MCF5485 Reference Manual Errata

This errata document describes corrections to the *MCF5485 Reference Manual*, order number MCF5485RM. For convenience, the addenda items are grouped by revision. Please check our website at <http://www.freescale.com/coldfire> for the latest updates.

The current version available of the *MCF5485 Reference Manual* is Revision 5.

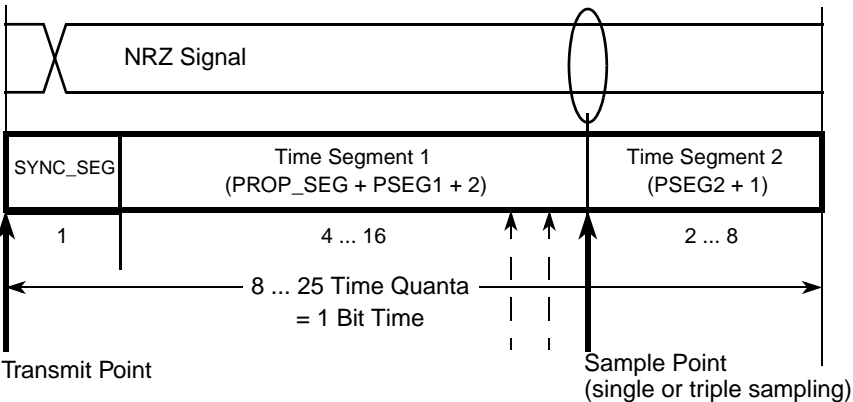
Location	Description
<p>Section 2.2.6.1/Page 2-24</p> <p>Figure 1 correlates CLKIN, internal bus, and core clock frequencies for the 1x–4x multipliers.</p> <p style="text-align: center;">Figure 1. CLKIN, Internal Bus, and Core Clock Ratios</p>	<p>Add the following after Table 2-4:</p>
<p>Section 3.8.1/Page 3-40</p>	<p>Change the second sentence of the first paragraph from “The second holds the 32-bit program counter address of the faulted instruction.” to “The second holds the 32-bit program counter address of the faulted or interrupted instruction.”</p>
<p>Table 3-23/Page 3-44</p>	<p>The “Interrupt exception” entry’s description is outdated. Change from “Interrupt exception processing, with interrupt recognition and vector fetching, includes uninitialized and spurious interrupts as well as those where the requesting device supplies the 8-bit interrupt vector. Autovectoring can optionally be configured through the system interface module (SIM).” to “Please refer to Chapter 13 ‘Interrupt Controller.’”</p>
